State of Alaska
Department of Fish and Game
Sportfish Division

Nomination Form
Anadromous Waters Catalog

Anadromous Waters Catalog Number of Waterway: 111-50-10420-2002 and 111-50-10420-2003

Name of Waterway: Cali Creek

Figure 1 Map of Area

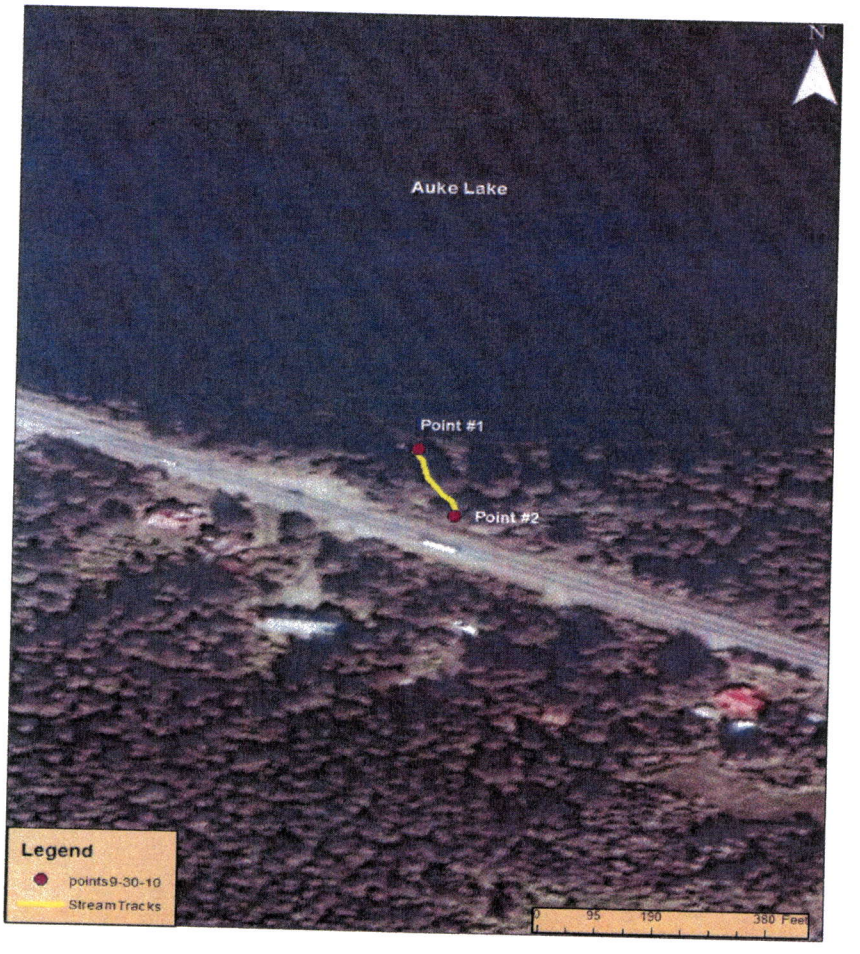
On 9-30-10 I tracked this small tributary to Auke Lake. The tributary has well defined streambed and banks and appears to provide good rearing habitat. A perched CMP @ Glacier Hwy has created a plunge pool (Point #2), and is currently a fish barrier. I placed one minnow trap near the confluence with Auke Lake (point #1) and trapped 2 Dolly Varden (60, 120mm), 2 coho (70mm), and 2 sculpin. I placed another trap in the plunge pool near Glacier Hwy (point #2) and trapped 2 coho (50-60mm), and 2 Dolly Varden (120mm). Traps were set for 1 hour.

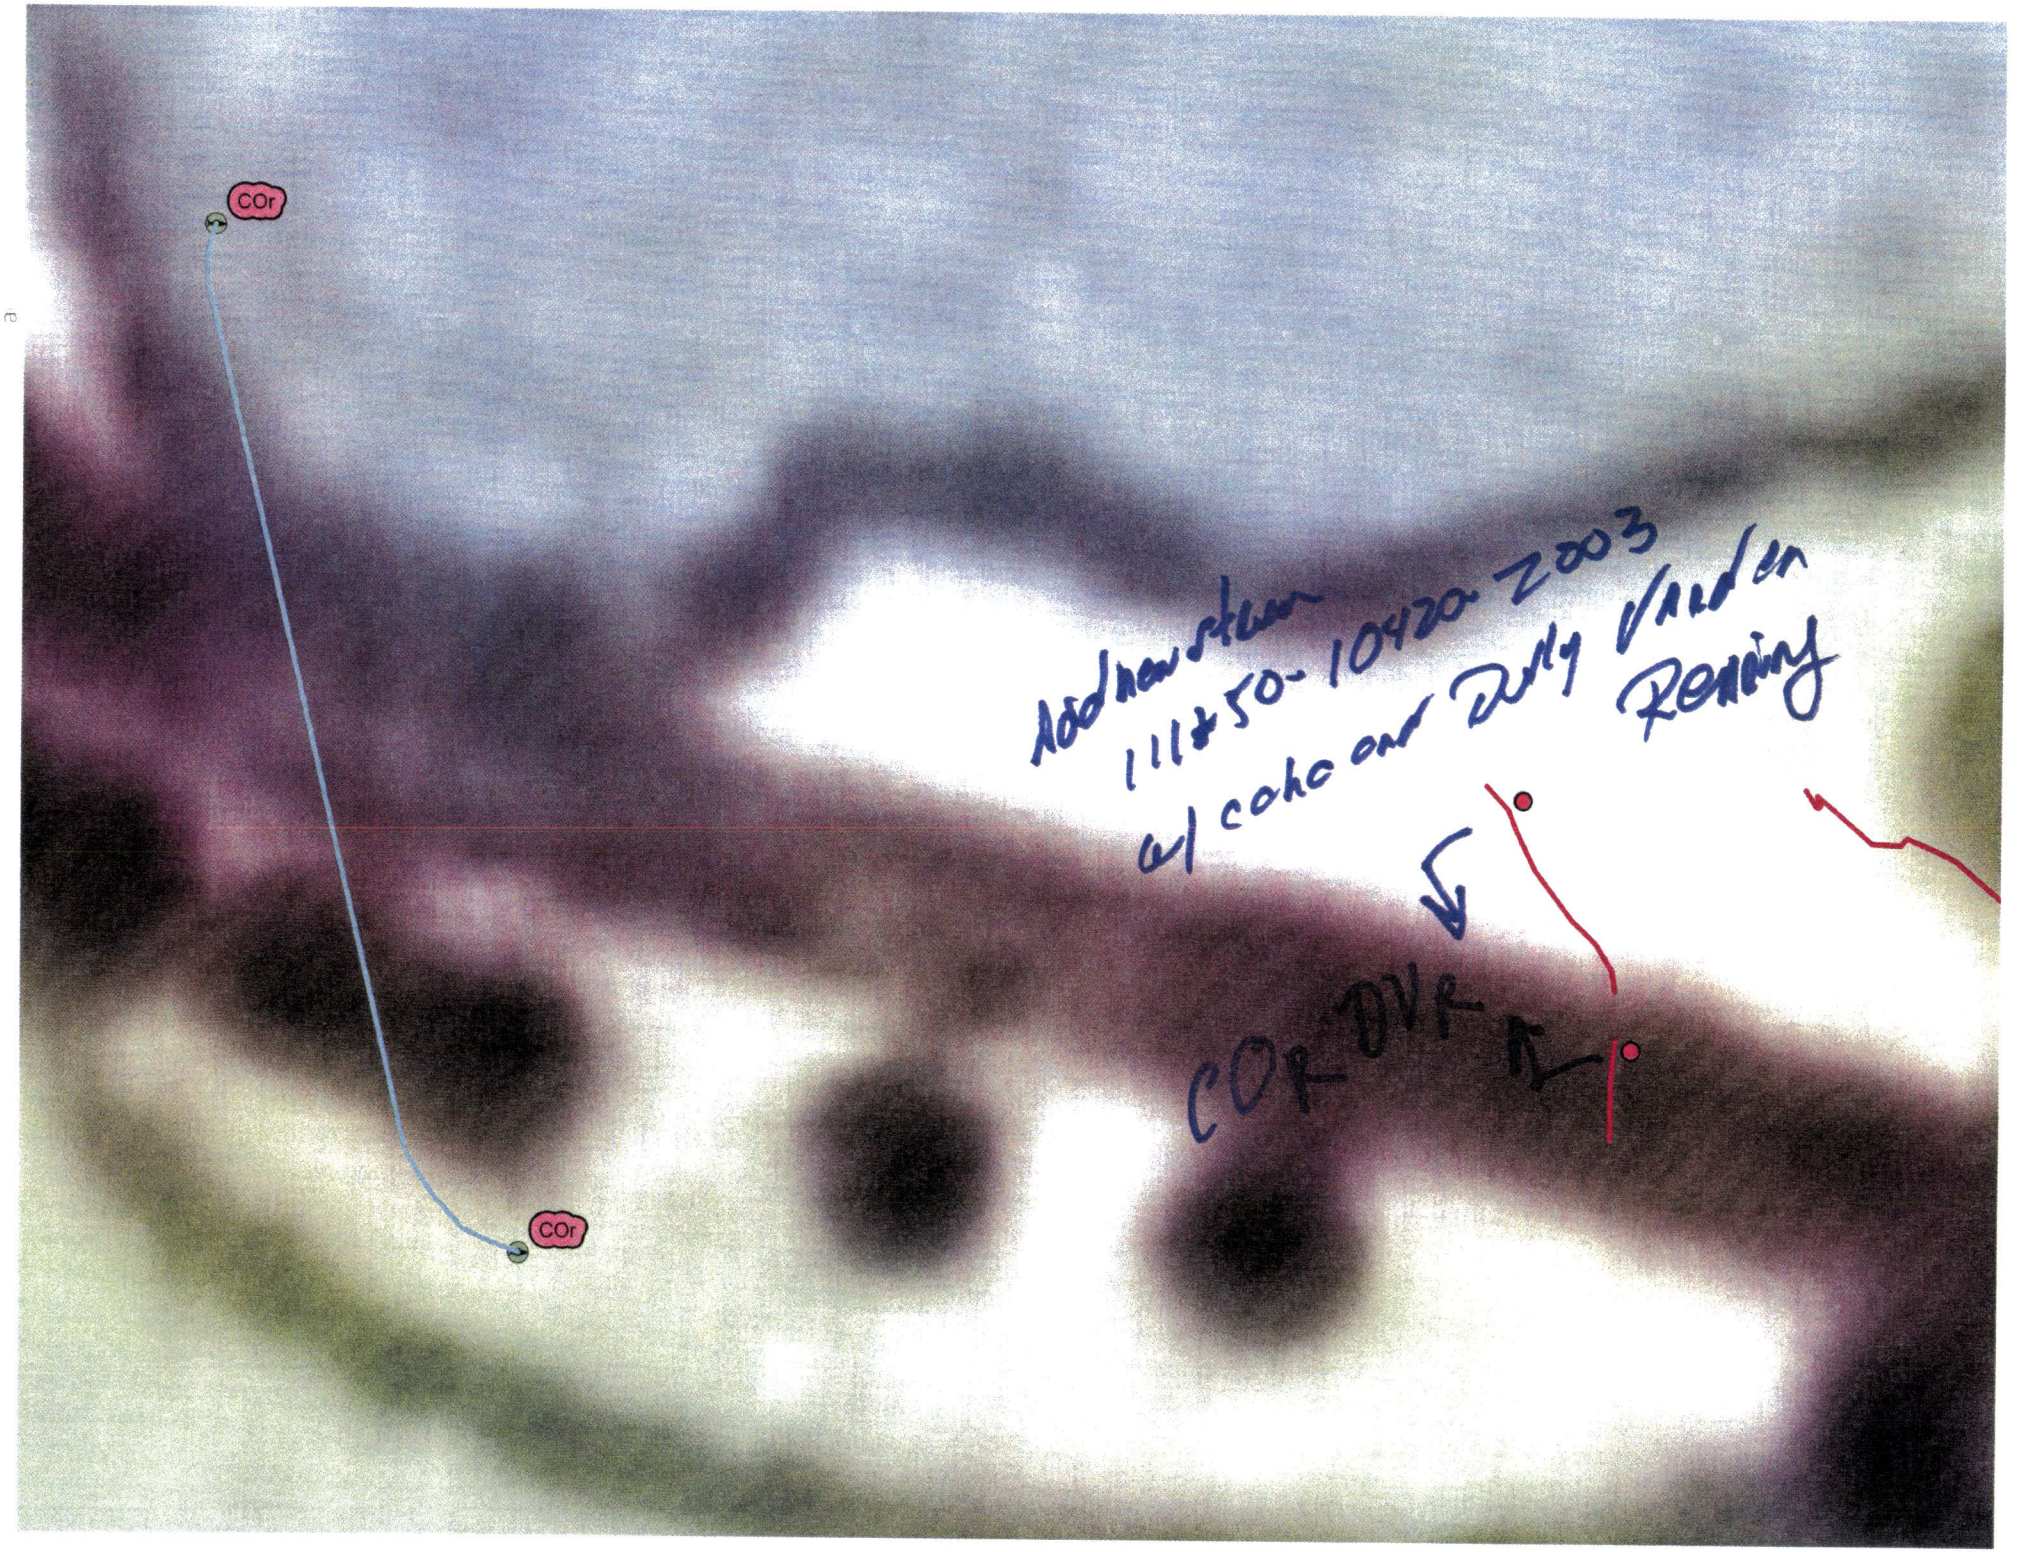
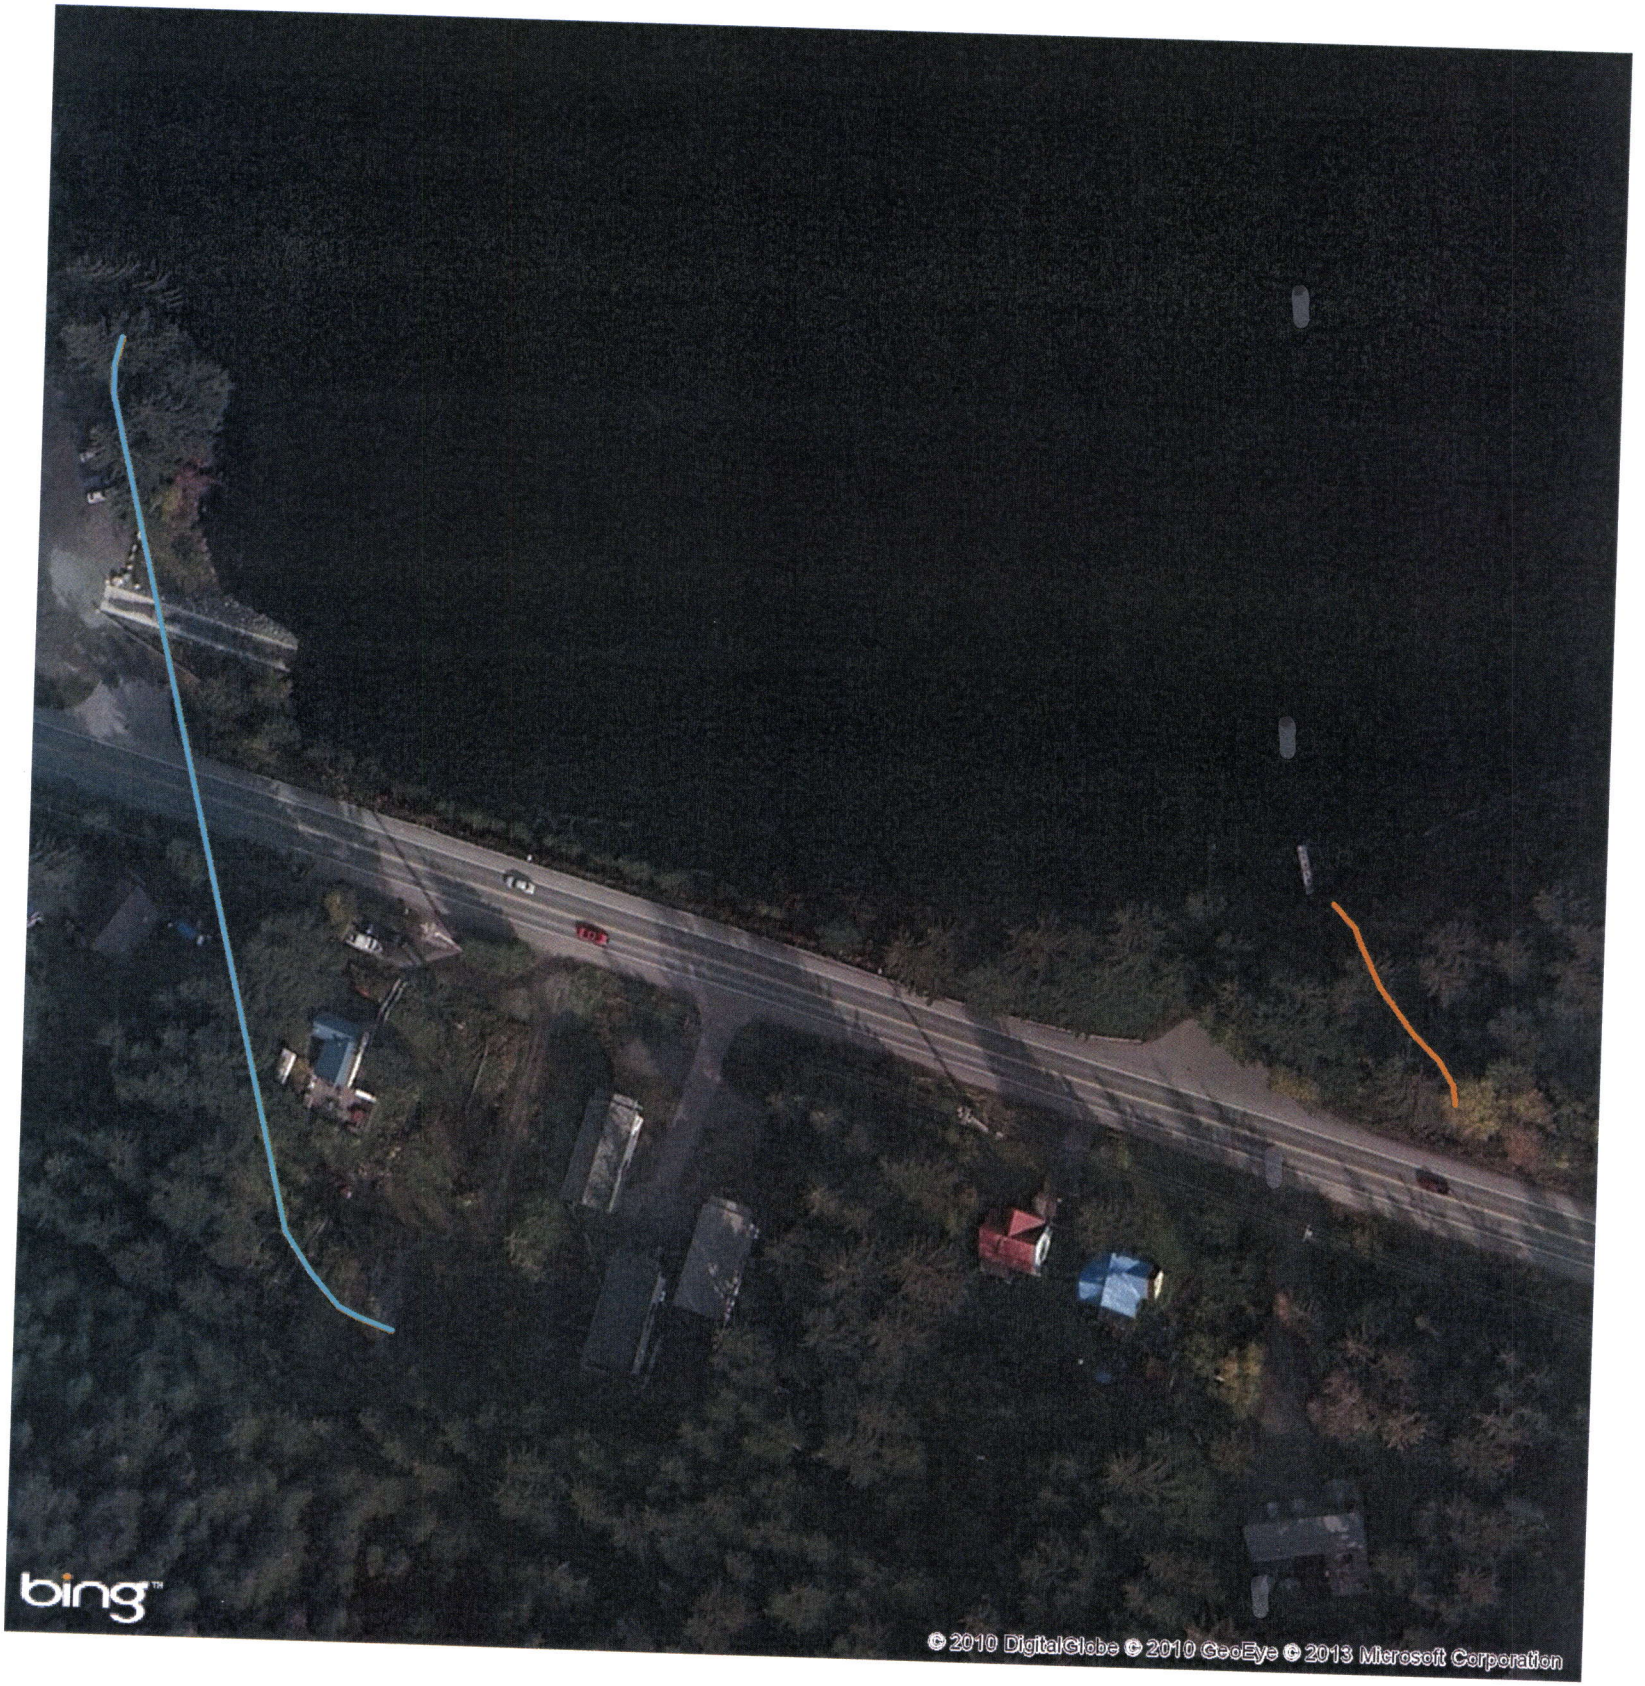
The mapped location for stream # 111-50-10420-2002 should be deleted, as no stream is present there. Stream # 111-50-10420-2003 should be changed to 111-50-10420-2002, as this was the correct location for the original nomination, but was submitted as a new stream.

COr
COr
Addnewstown
111&50-10420-2003
w/ coho and Duly Vanden
Renning
COR DVR

Delete 111-50-10420-2002,
Renumber 111-50-10420-2003 as 111-50-10420-2002
